STAFF REPORT 1/19/2022

TO: Planning Commission

FROM: Gabriel Perez, Development Services Director

SUBJECT: Coachella Sunline Transportation Hub (Architectural Review No 21-13)

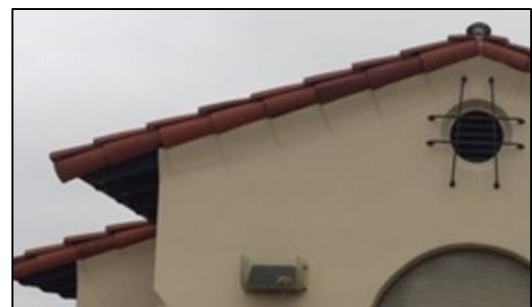
6. Slake the stucco at the edge of the gable roof on the Sunline building to encapsulate the tile.

This creates an attractive shadow pattern
